Date: 6/9/2026	Rev.: FR	No.: B26017
Re.: Reflective Tape Recall 26V-323	Type: Safety	
Priority: As soon as practical		
Units Affected: Forklift and C-channel Rear plates

Background: We have determined that some Steel and Combo Flatbed Trailers with Forklift or C-channel rear plates do not meet S8.2.3 of FMVSS 108 reflective tape requirements. This bulletin will explain the steps needed to repair the unit to comply with the current FMVSS standard.

HEAVY DUTY STEEL CHANNEL REAR PLATE
W/ LEGS OUTWARD
DOCK BUMPERS
DONKEY FL

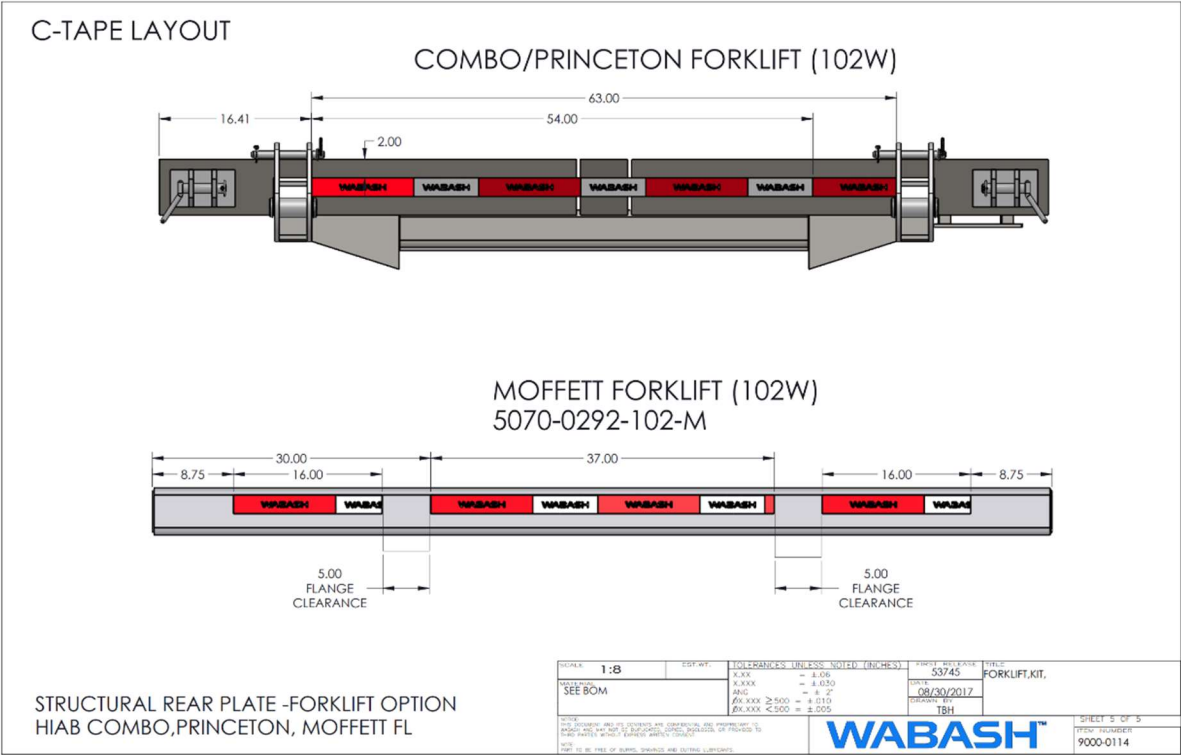
2. Identify which rear plate configuration is on the unit and install reflective tape according to prints provided below:

Note: On certain Models: Stop / Taillights may need removed to properly install the reflective tape per prints below. Reflective tape will need to be trimmed around the edges of the holes and lights re-installed.
